SOUTH BATTERY PARK CITY RESILIENCY

CB1 UPDATE

MARCH 21, 2022

PIER A PLAZA | PREVIOUS DESIGN

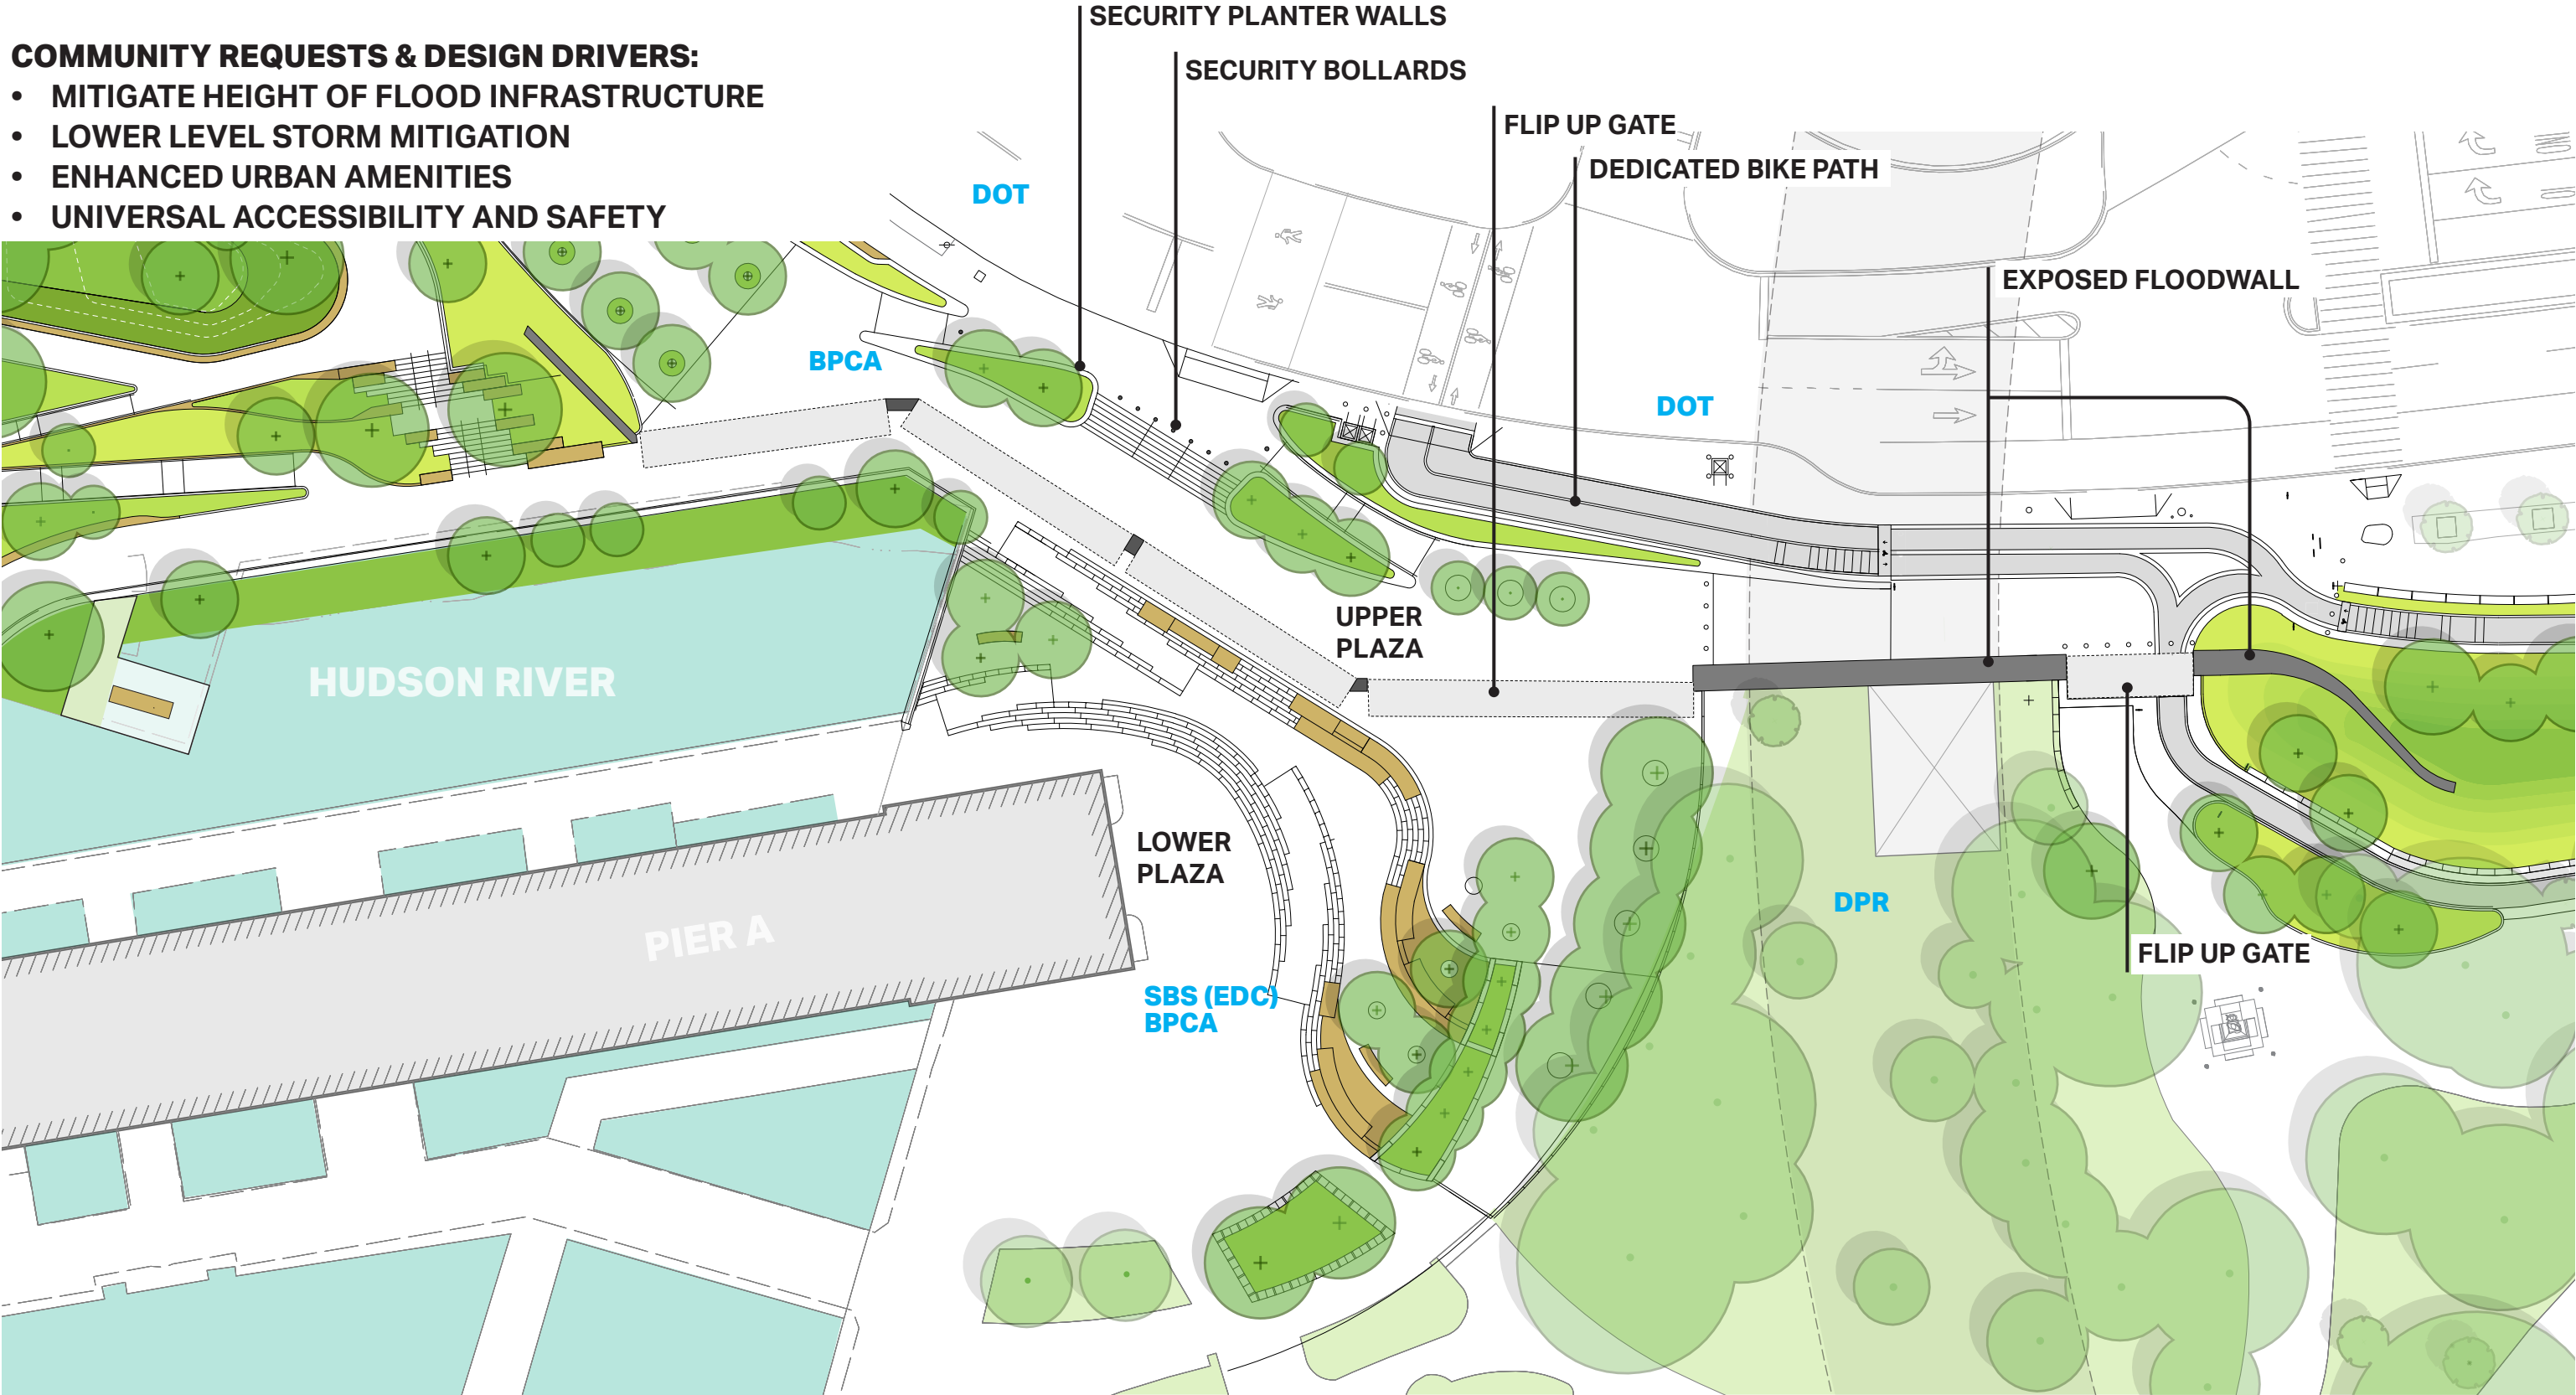
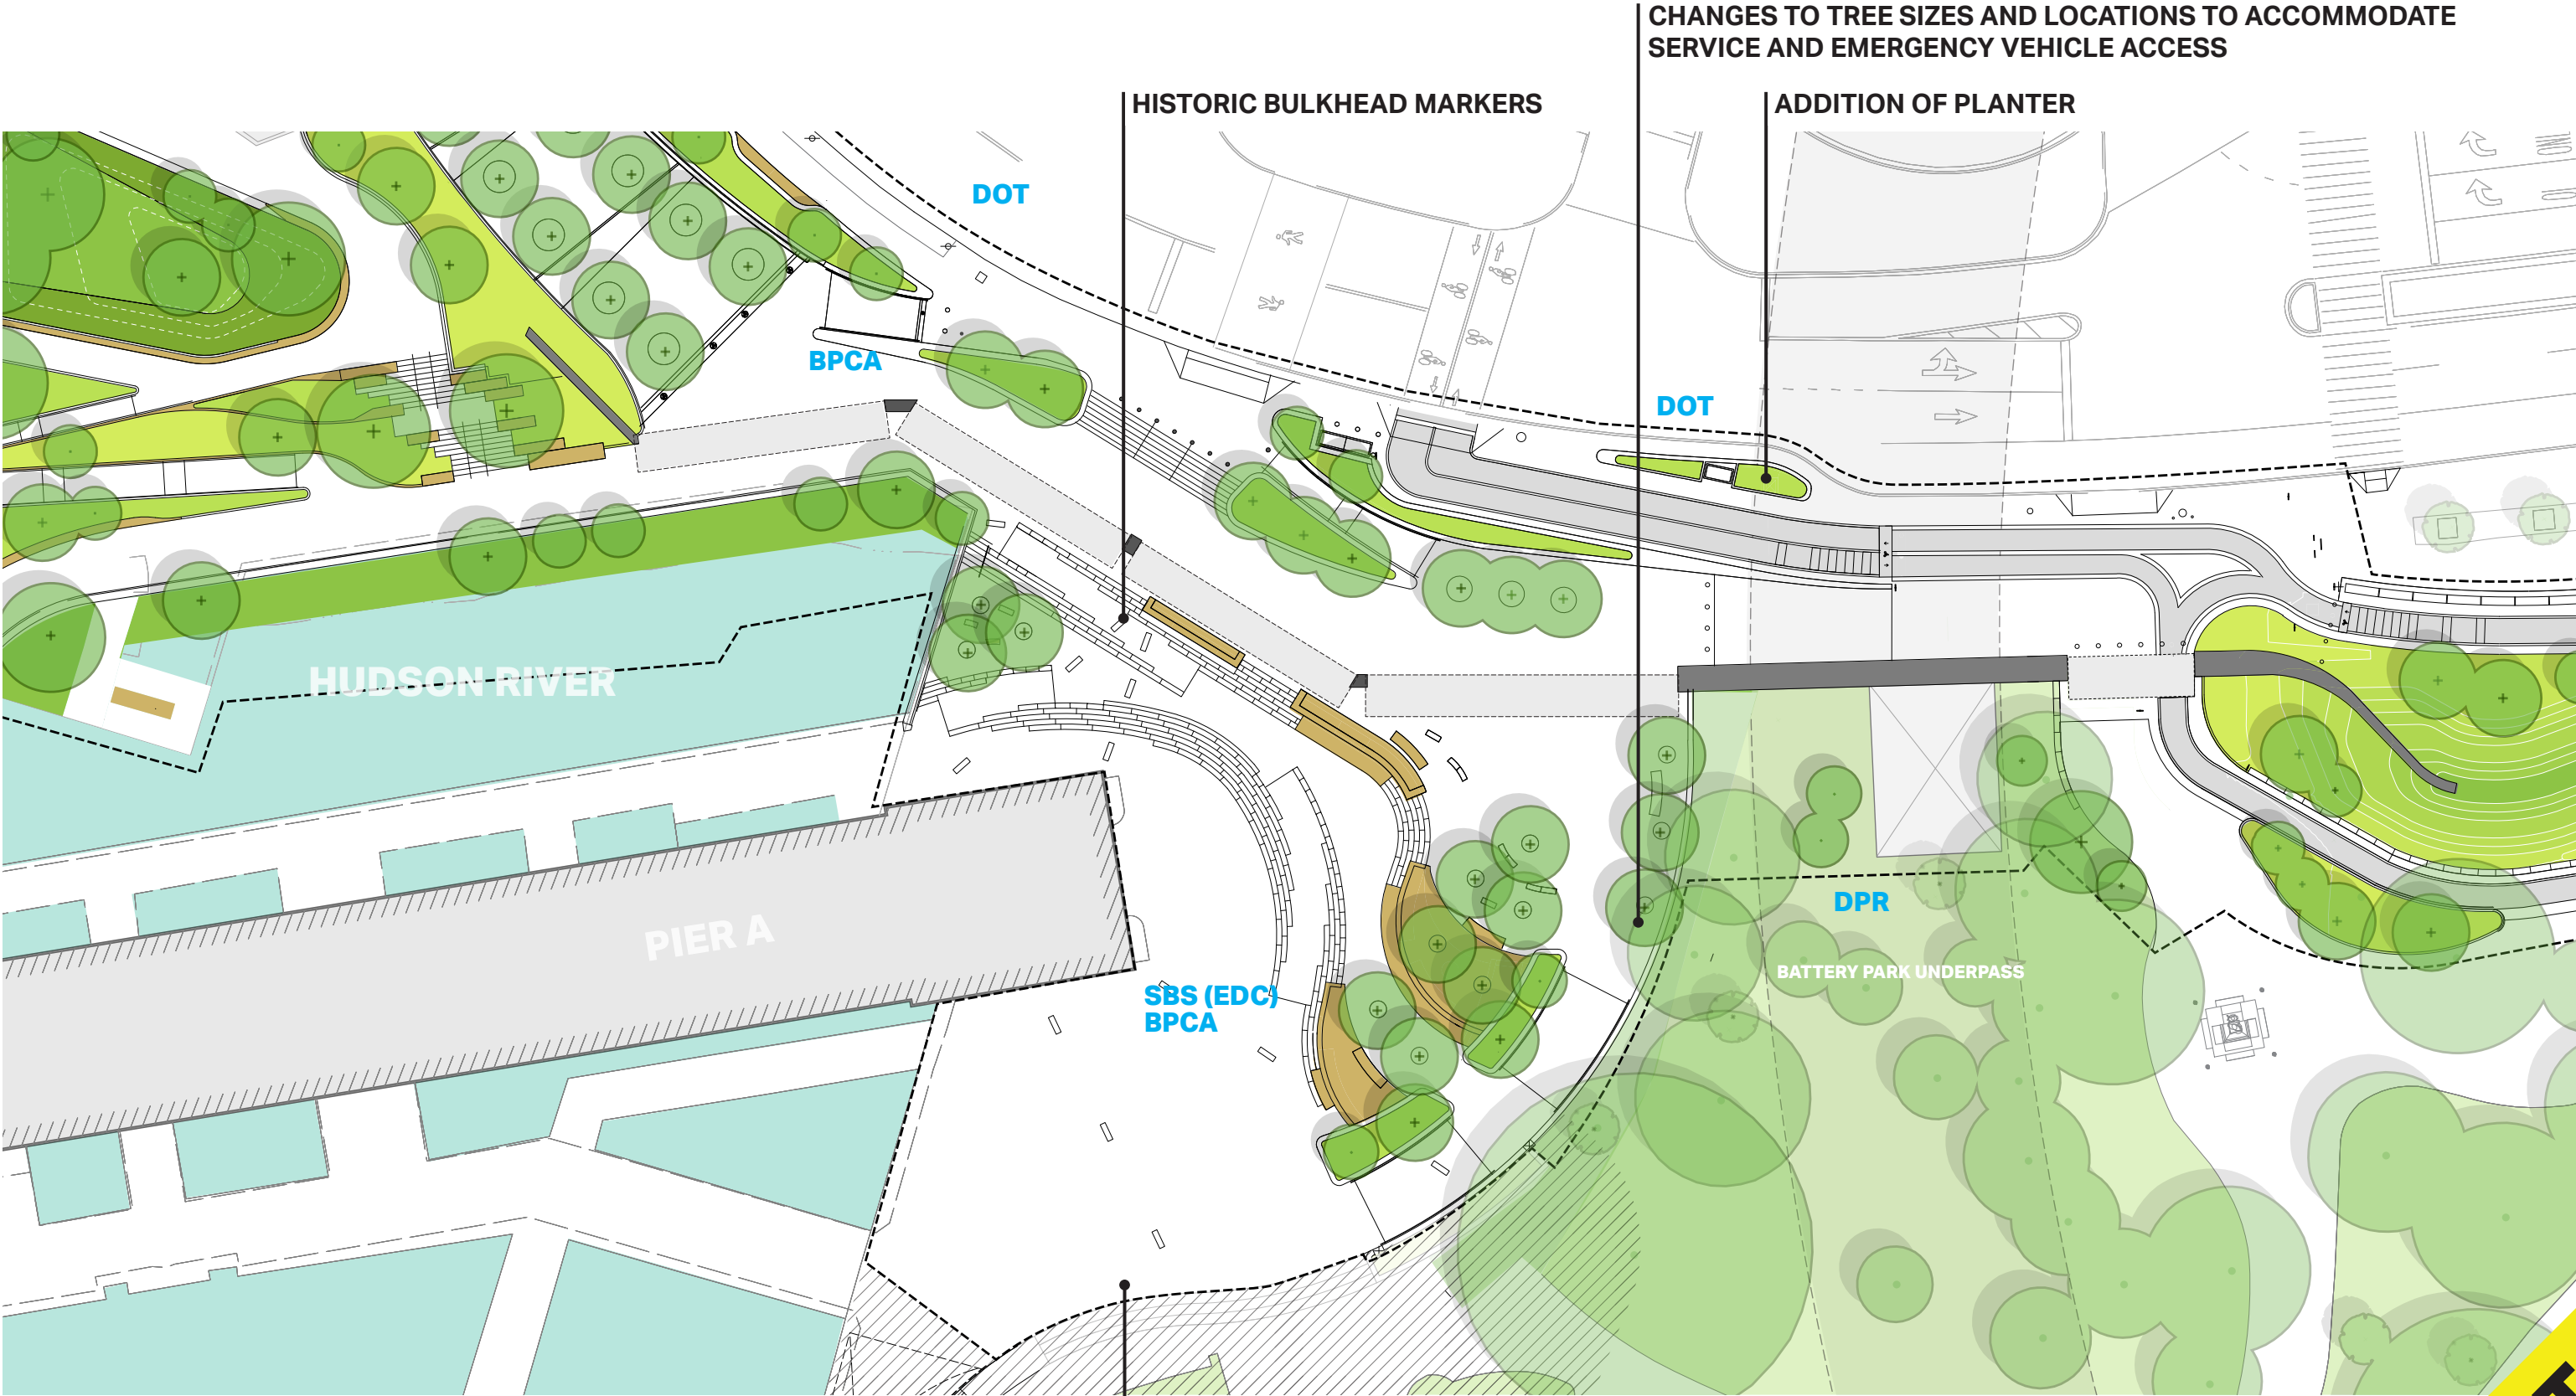
- Revise arrangement of bollards, hydraulic power units, and planting to enlarge the planted buffer and minimize bollards along bikeway
- Continue to study the detailing and durability of the wooden seating elements at Pier A plaza
- Reconsider the ground lighting under the benches within Pier A plaza and along the floodwall
- Maximize use of solar lighting
- Provide details on the stone cladding at the flood walls
- Provide details on the engineering and functionality of the deployable gates

CHANGES TO TREE SIZES AND LOCATIONS TO ACCOMMODATE SERVICE AND EMERGENCY VEHICLE ACCESS

ADDITION OF PLANTER

CHANGE IN PLANTER ARRANGEMENT DUE TO BATTERY RESILIENCY EXTENTS & AND ACCESS FOR DEP SERVICE VEHICLE & EMERGENCY VEHICLE
